**CER 4. REQUEST FOR EQUALS
RETURN WITH YOUR PROPOSAL**

Company Name: GILLIG LLC

Specification Section Number: TS 10.4 Engine/Transmission Oil Fill/Filters

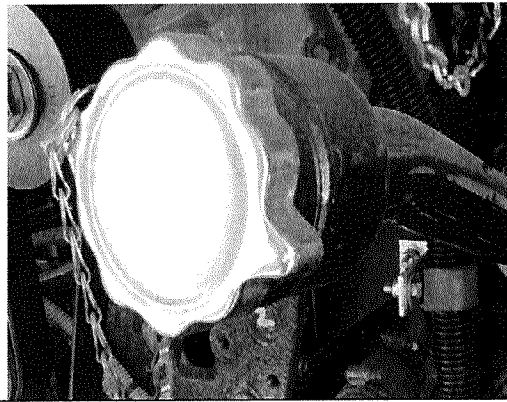
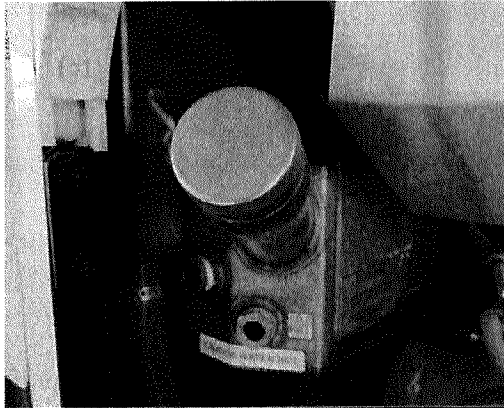
Component Item Listed:
Engine oil and the radiator filler caps shall be hinged to the filler neck and closed with spring pressure or positive locks to prevent leakage.

Proposed Item:
GILLIG requests approval to provide twist on engine and radiator filler caps as seen below. Each cap is designed to provide a positive lock which prevents leakage. Each cap is securely tethered to each fill neck assembly to prevent loss or misplacement of the caps while filling. GILLIG requests approval of our proven standard installation.

OK RC
